TOWN OF YORKTOWN PLANNING BOARD

PUBLIC MEETING AGENDA YORKTOWN TOWN HALL BOARD ROOM 363 Underhill Avenue, Yorktown Heights, NY 10598

February 28, 2022
7:00 PM

4. **Kitchawan Solar**
Discussion Site Plan & Special Permit
Location: 70.06-1-2 & 3; 716 Kitchawan Road
Contact: Ecology Kitchawan Community Solar Farm, LLC
Description: Proposed 2 MW ground mounted large-scale solar energy system.

Drawing No.
L-1
 SHEET 1 OF 4

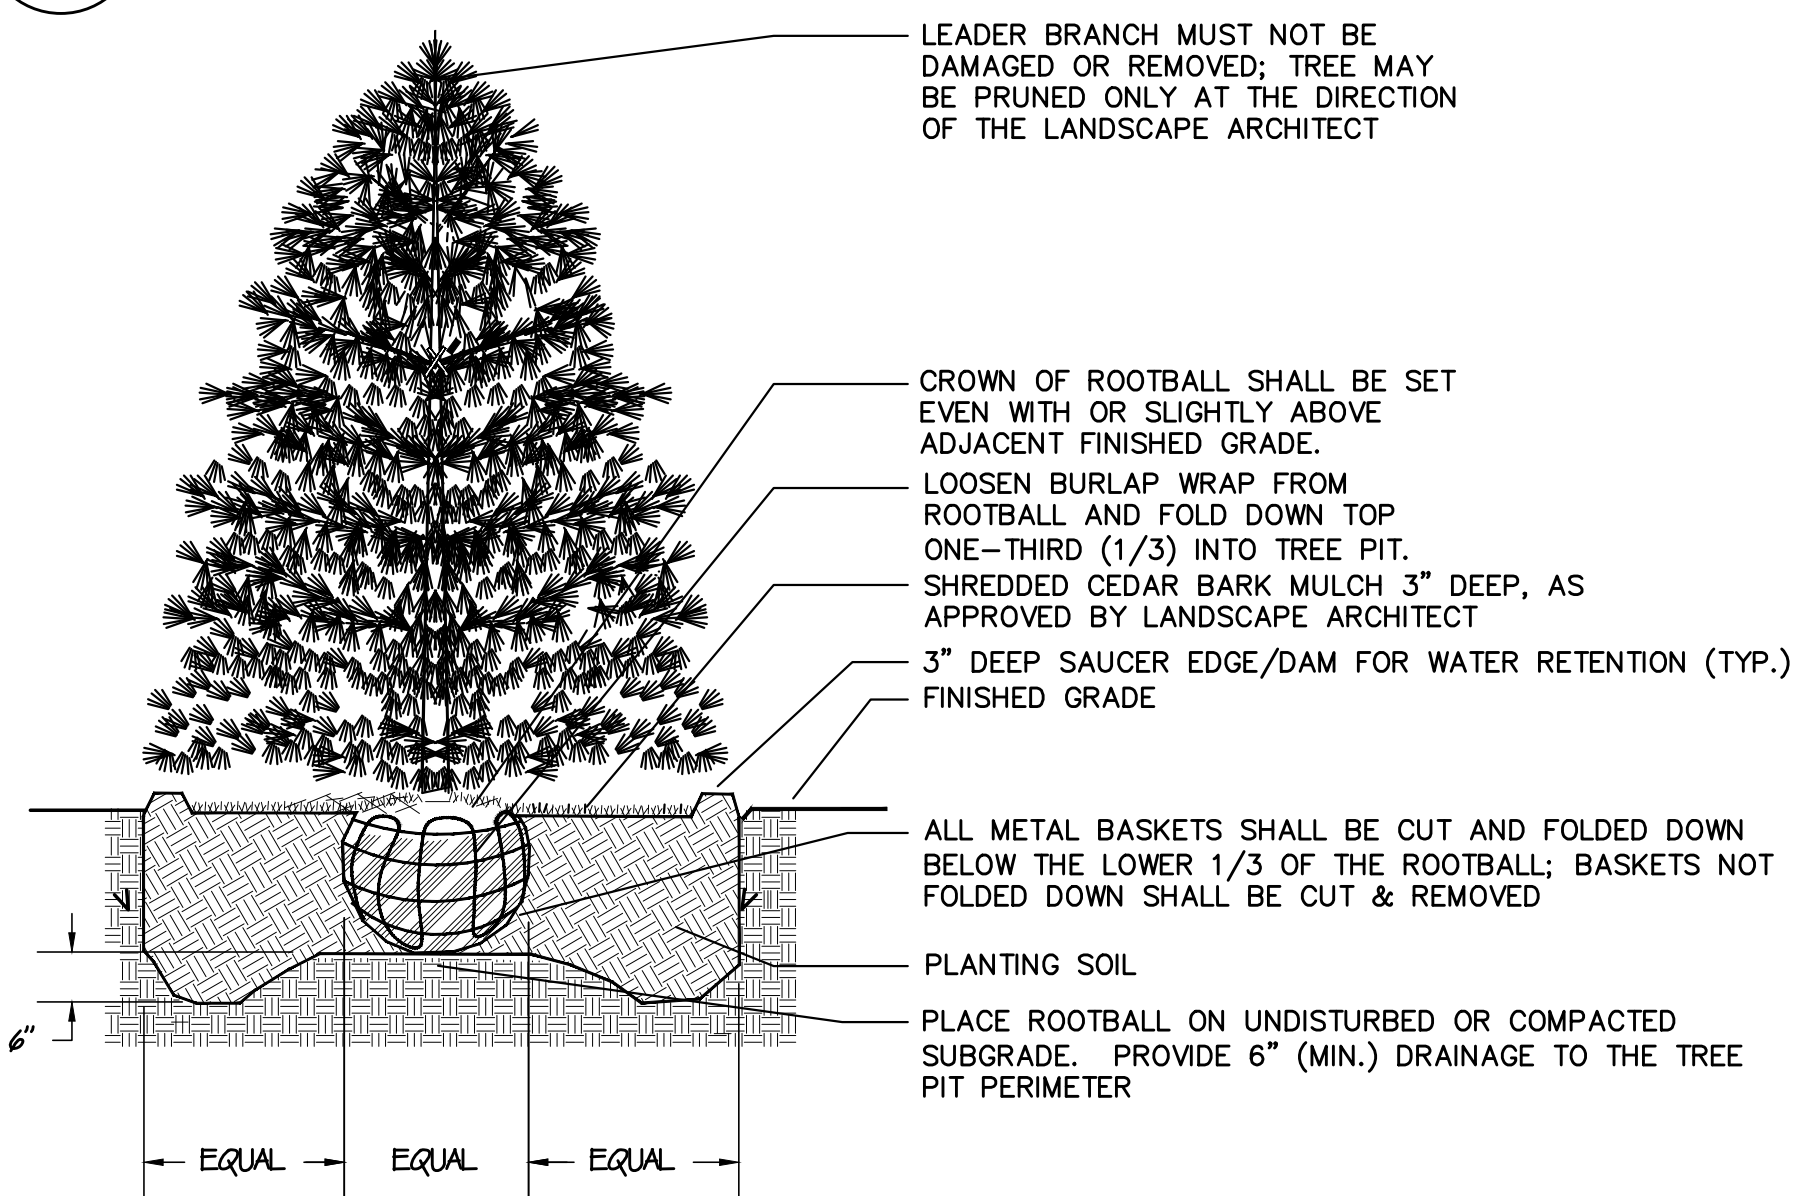
3. The Engineer has not provided a mitigation ratio or a tree deficit calculation as required by Chapter 270-4.
4. Many of the proposed trees listed on Drawing L-4, PLANTING DETAILS, PLANT LIST & PLANTING NOTES, have sizes listed with heights instead of DBH's. All proposed trees need to be listed with DBH's. Without DBH's, a mitigation ratio cannot be calculated.
